Illinois Power Company
Clinton Power Station
P.O. Box 678
Clinton, IL 61727
Tel 217 835-8881

Subject: Clinton Power Station
Proposed Resolution of Issues Related
to NRC Review of Inservice Testing Program

RELIEF REQUEST 2008 (Revision 3)

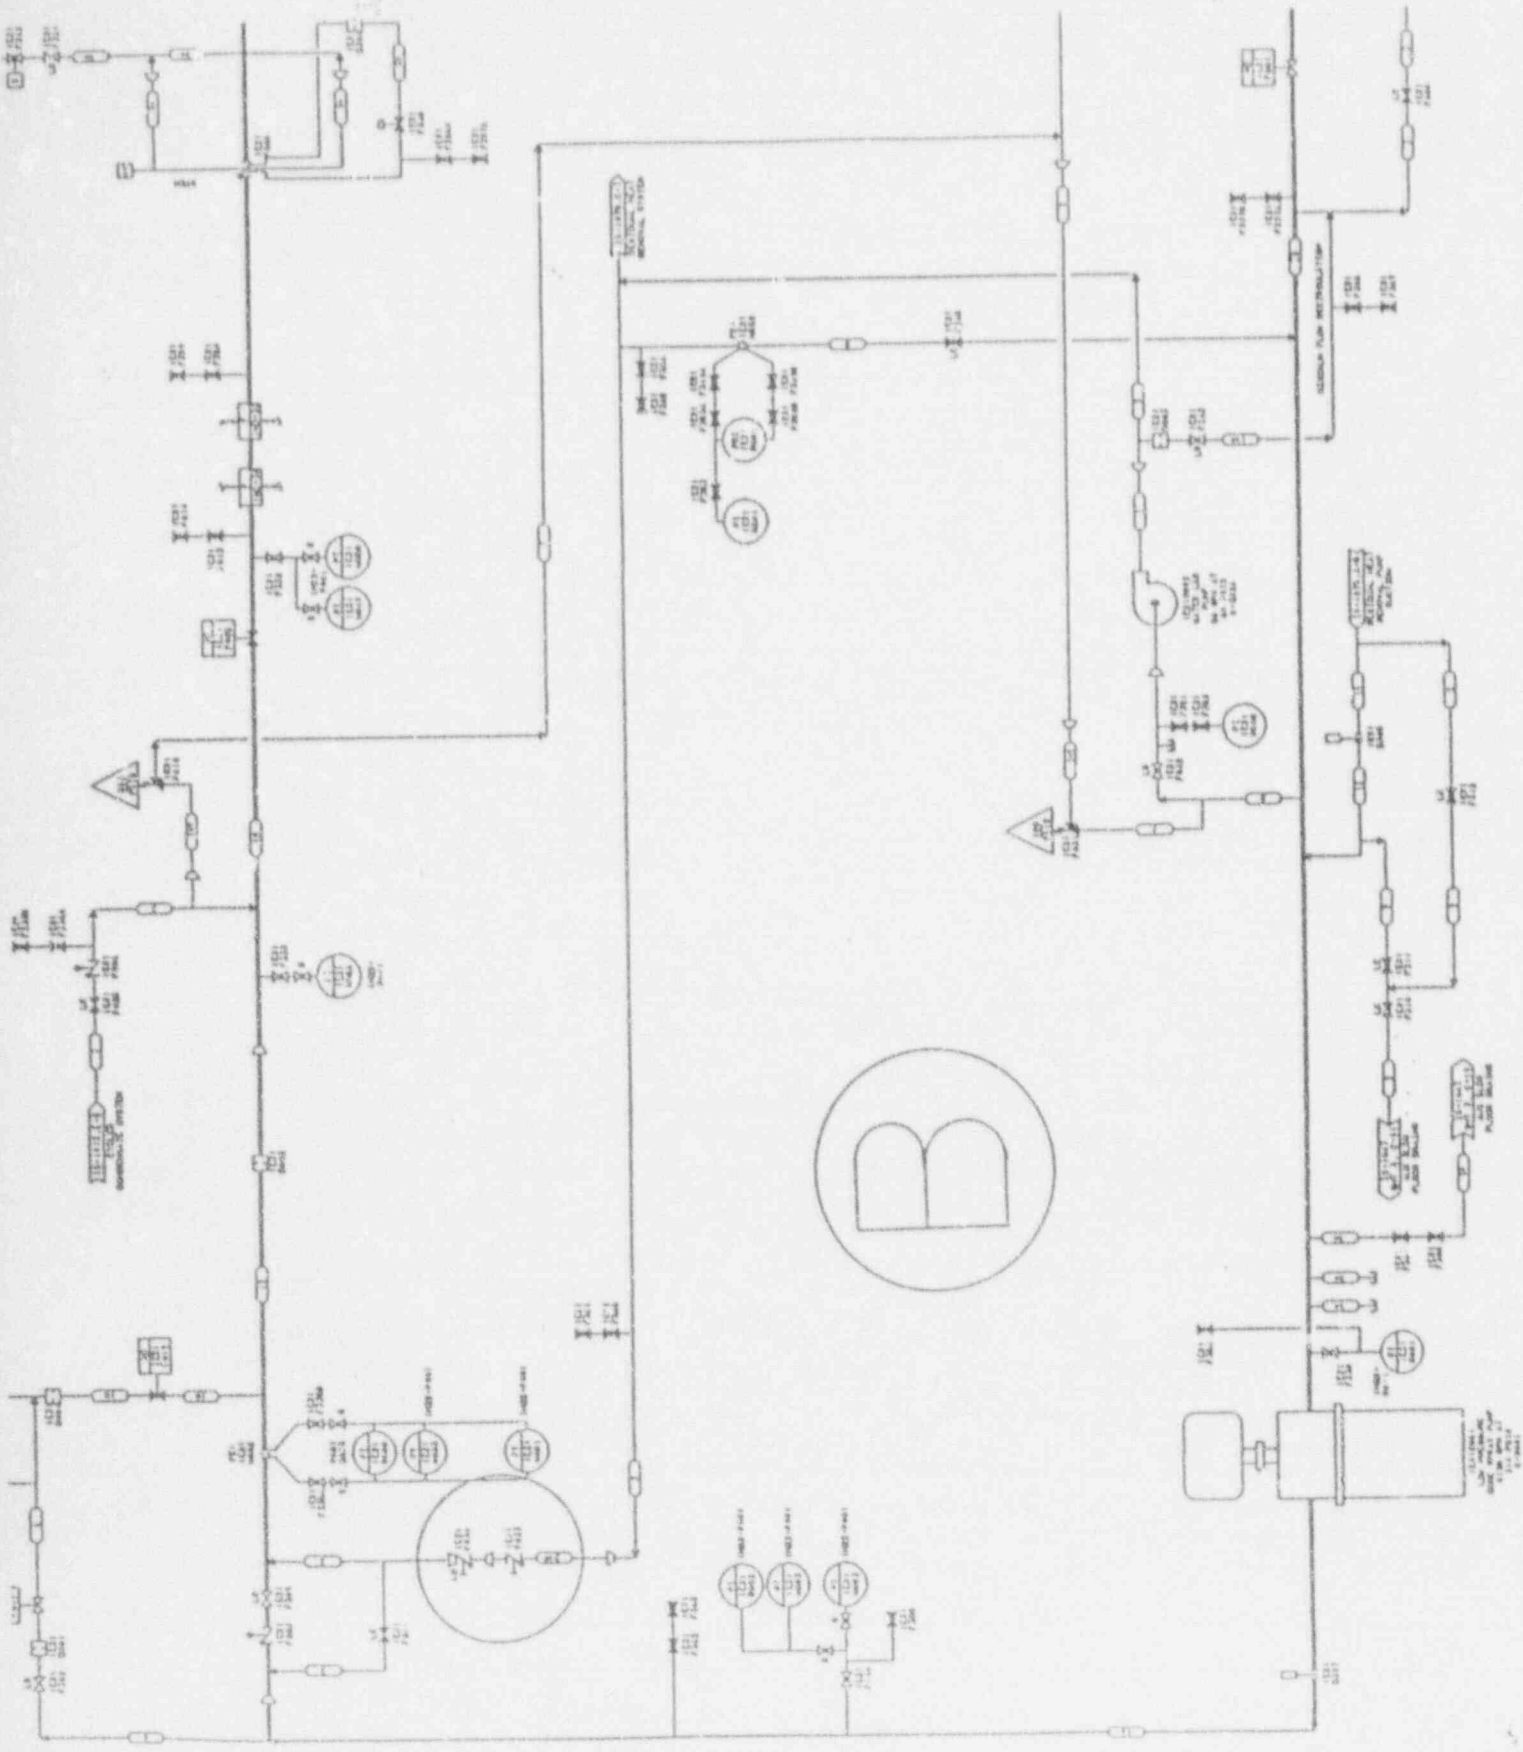
Valve 1E22-F006 is located between High Pressure Core Spray (HP) water-leg pump and the main HP injection line. It is a 2-inch stop-check valve, ASME Section III Class 2, Section XI Category C. It is circled on the attached drawing "A".

Valves 1E12-F085A,B,C and 1E21-F034 are located between the water-leg pumps and their respective injection lines (Residual Heat Removal (RHR) and Low Pressure Core Spray (LP)). They are ASME Section III Class 2, Section XI Category C valves. They are 2-inch stop-check valves of identical design. As their piping configuration is similar, only 1E21-F034 is circled on the attached drawing "B".

The above groups of valves, although located in separate systems, have similar configurations; they are check valves located in series with other check valves and no test connections provided between them to permit individual valve testing.

Each of these valves has a separate check valve in series. The two check valves in series, although not required by design or safety analysis, provide an added assurance that the high pressure Emergency Core Cooling System (ECCS) line will not damage the lower pressure water-leg piping. Illinois Power Company considers these two check valves in series as a single entity and will test them as such.

Illinois Power Company considers these two check valves in series a single entity and will perform the closure test every three (3) months as a single unit. Acceptance criteria will be established and in the event of not meeting this criteria, appropriate action will be initiated for the entity and the deficiency will be corrected.

The open exercise of these valves will also be performed every three (3) months.

RELIEF REQUEST 2014 (Revision 2)

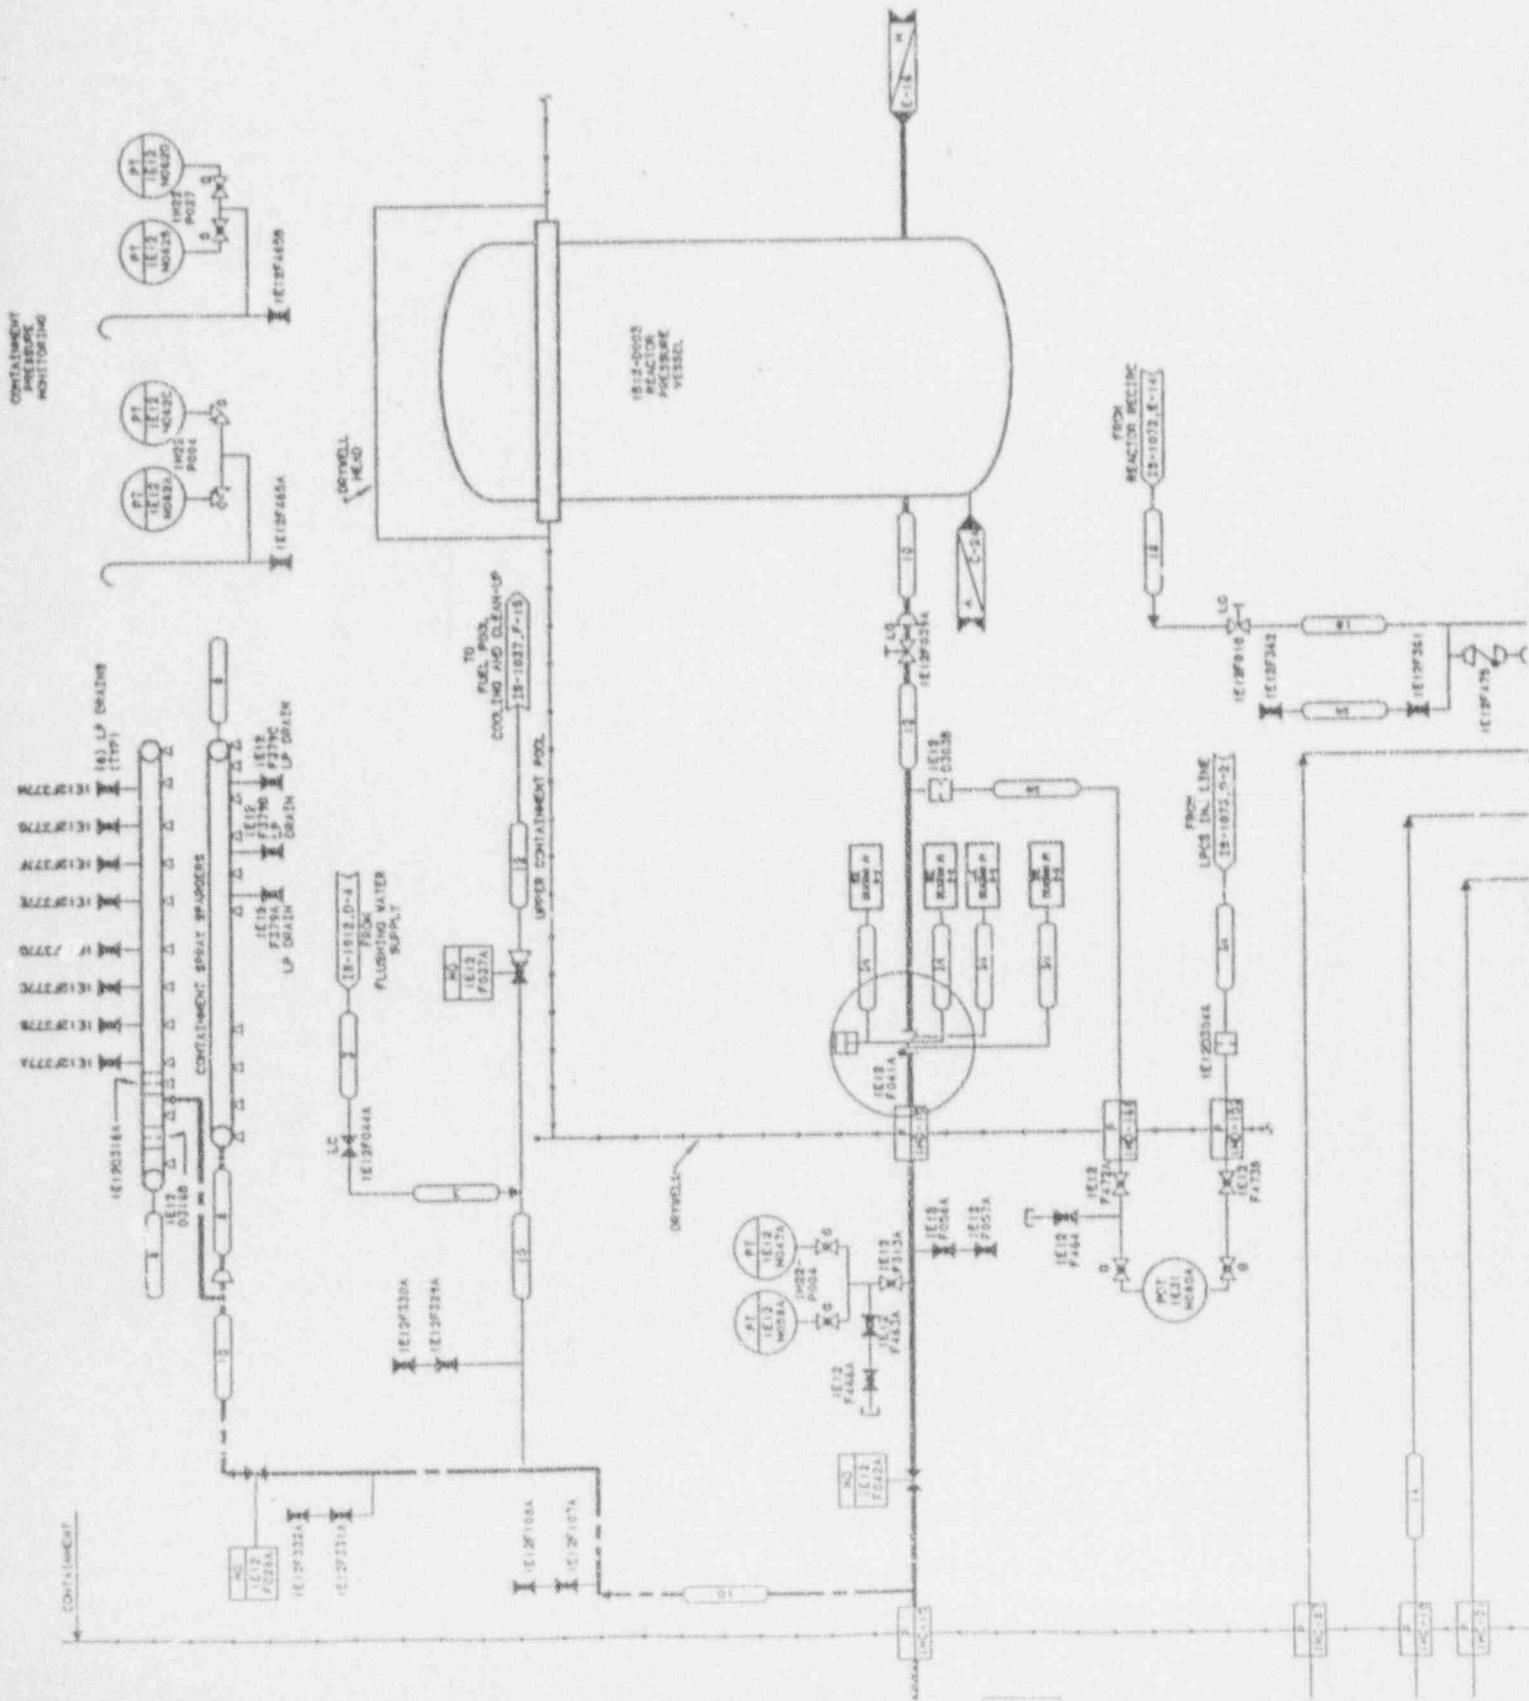
These testable check valves (1E12-F041 A/B/C, 1E21-F006, and 1E22-F005) provide isolation from the reactor coolant system and the emergency core cooling systems (Residual Heat Removal, Low Pressure Core Spray, High Pressure Core Spray). These valves are ASME Section III Code Class 1, Section XI Category A/C valves. Valves 1E12-F041 A, B, and C are 12" diameter and valves 1E21-F006 and 1E22-F005 are 10" diameter. All of these valves are non-slam check valves. One of these valves (1E12-F041A), which is typical of the group, is circled on the attached drawing.

Exercising these valves on a three month frequency using the emergency core cooling system pumps to inject water into the reactor is not in the interest of plant safety, because this cooler water would create an undesirable power transient. In addition, neither the Low Pressure Core Spray nor Residual Heat Removal pumps are capable of opening their injection valves against full reactor pressure. Mechanically exercising these valves during reactor operation is not practical because they are located inside the drywell and access is restricted due to radiation conditions.

Mechanically exercising these valves on a cold shutdown frequency as allowed by the ASME Code is not practical because the air operator is not designed to perform a full stroke test. Although the air operator can be removed to perform the full stroke test, this is a significant maintenance activity and could interfere with work which is necessary to restore the plant to service. This would create an unreasonable hardship for Illinois Power Company which is not consistent with the guidelines for cold shutdown testing which were provided in Generic Letter 89-04.

Using pump pressure to exercise these valves during cold shutdown is also not in the interest of plant safety. Although temperature could be matched fairly closely between the injection source (emergency core cooling systems) and the reactor, a minor thermal mismatch between these temperatures creates an undesirable effect on the fatigue life of the reactor nozzles.

Illinois Power Company will partial-stroke exercise these valves using the air operators during cold shutdown and full stroke exercise the valves by removing the air actuator during refueling outages and measuring the torque required to lift the disc and then move the disc through a full stroke.

(GRAPH 1)

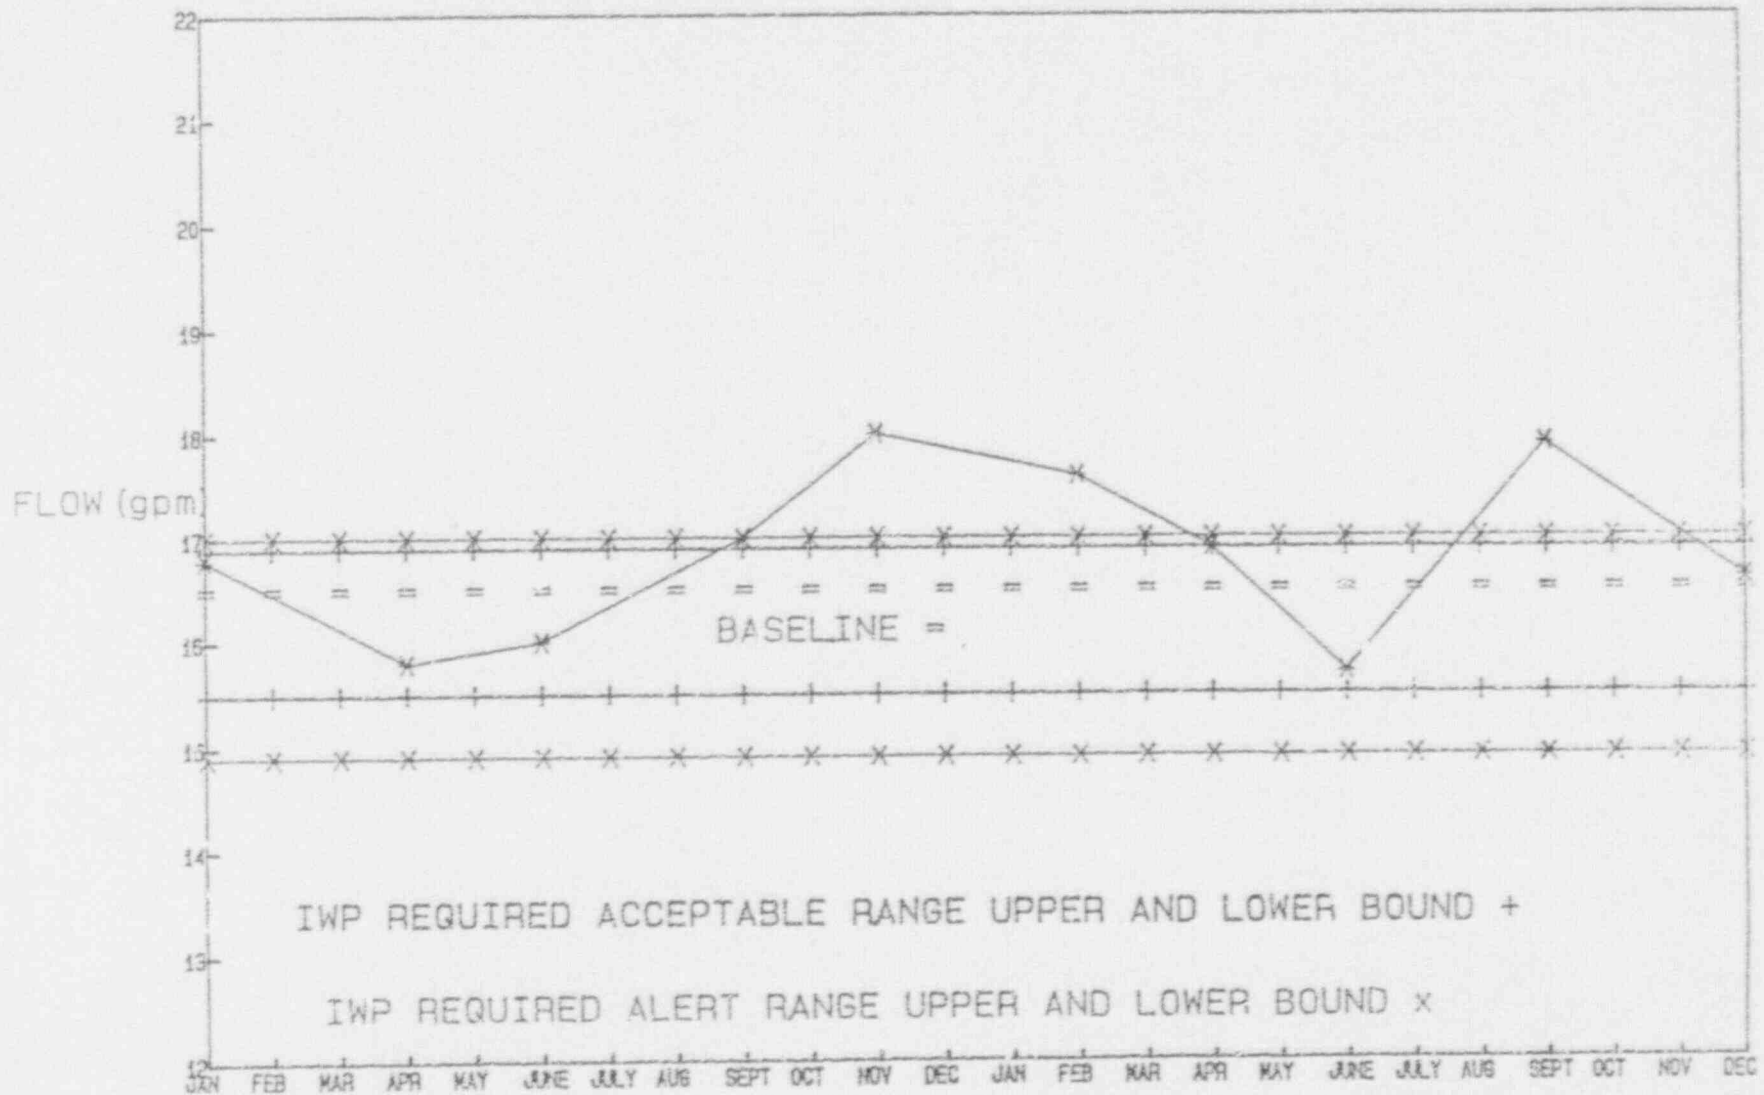
Because the DO pumps operate at a low flow and the Code specified acceptable ranges are based upon a percentage of the baseline, an increase in flow of less than 0.5 gpm (1.02 x baseline flowrate) is sufficient to force any of the pumps into the Required Action range. (SEE GRAPH 1)

PUMP 1D001PA (GRAPH 2)

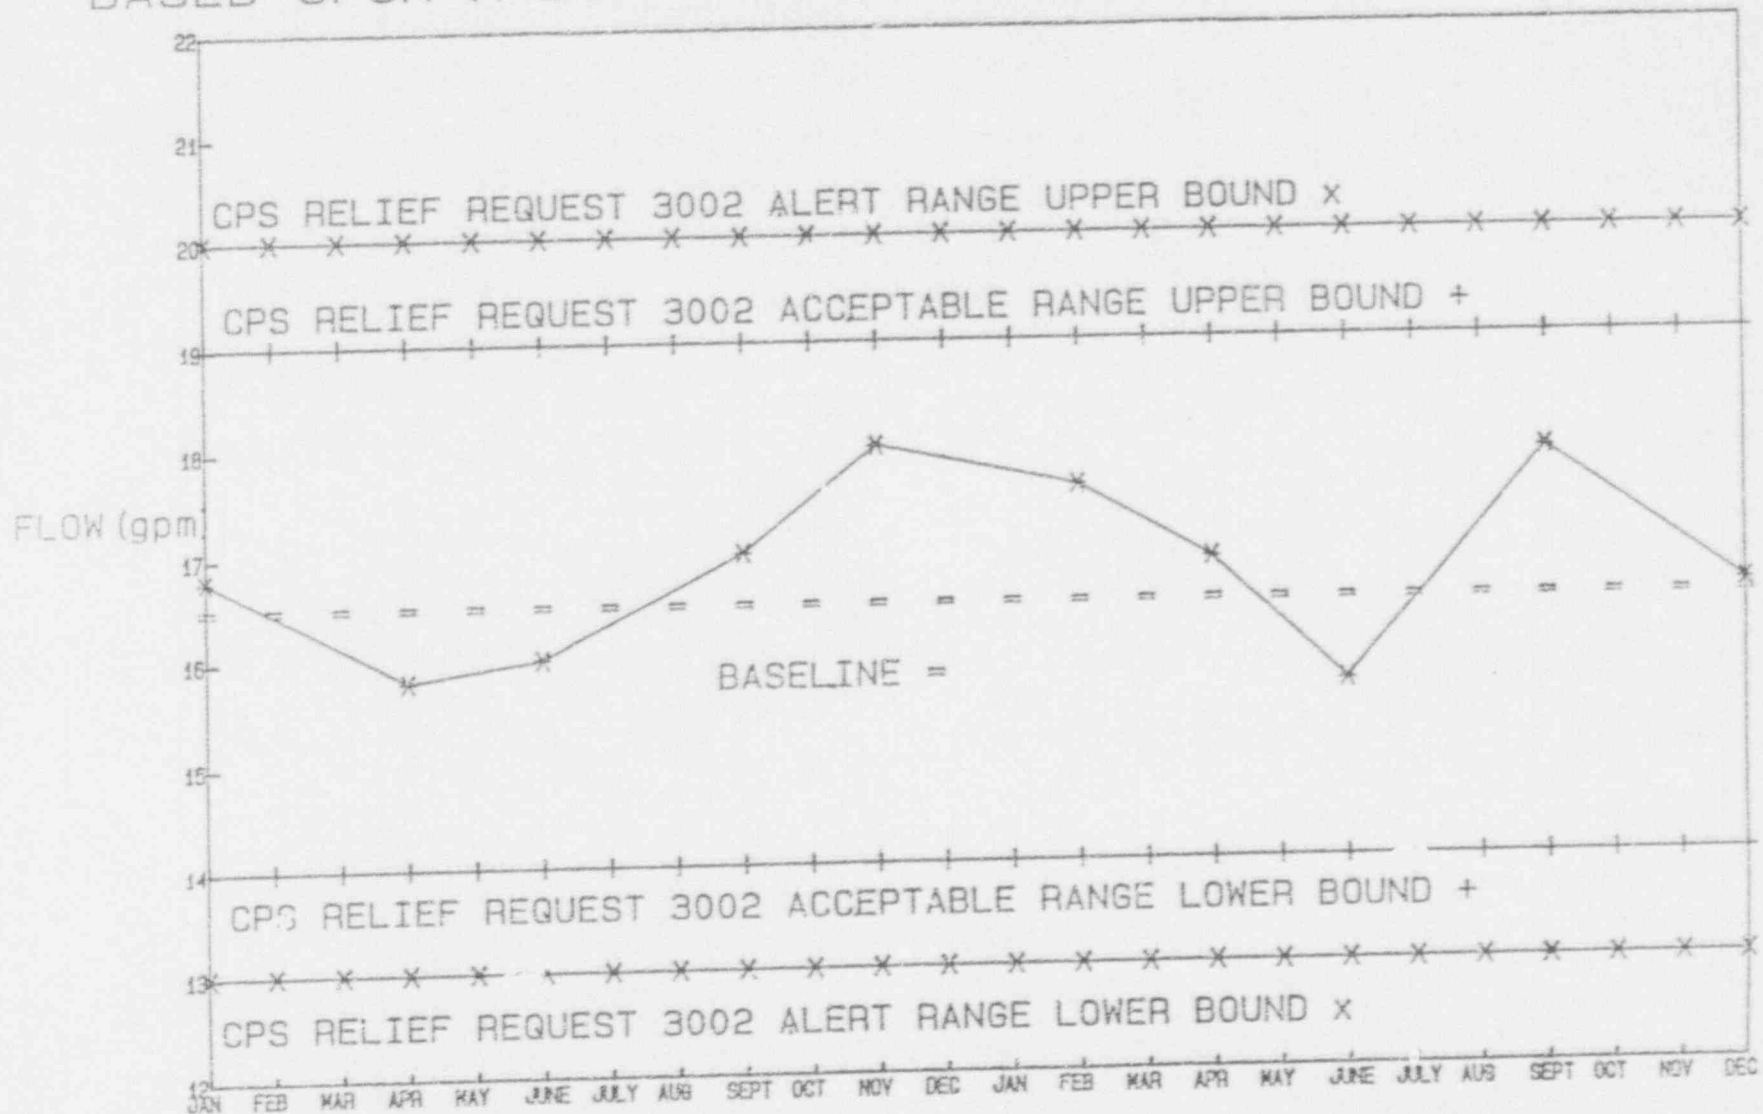
Based upon CPS's operating experience, CPS feels that the revised upper ranges will provide good indications of pump degradation without the unnecessary burden of requiring the pumps to be tested on an increased frequency or declared inoperable for minor (< 0.5 gpm) variations in flowrates. (SEE GRAPH 2)

Acceptable Range	≥ 14 gpm and ≤ 19 gpm
Alert Range	≥ 13 and < 14 gpm or ≥ 19 and < 20 gpm
Action Range	< 13 gpm > 20 gpm
